**Economic Commission for Europe**
**Inland Transport Committee**
**World Forum for Harmonization of Vehicle Regulations**
**Working Party on General Safety Provisions**
**126th session**

Geneva, 10–13 October 2023

**Report of the Working Party on General Safety Provisions on  
its 126th session**
**Contents**

"Figure 1

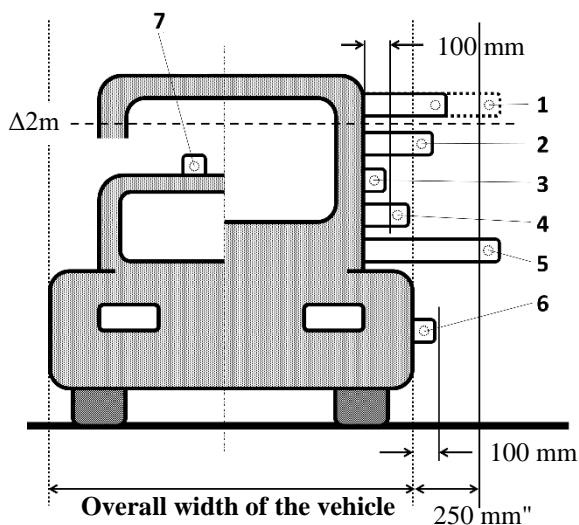
*Annex 9*, amend to read:

PENDULUM IMPACT TEST	
<u>Device for indirect vision CLASS II-VII</u>	
1	NO TEST (15.2.2.6.)
2	COMPULSORY
3	NO TEST (6.3.2.b))
4	NO TEST (6.3.2.a))
5	not permitted (15.2.2.6.)
6	NO TEST (6.3.2.b))
<u>Camera of CLASS I (CMS)</u>	
7	NO TEST (6.3.2.b)
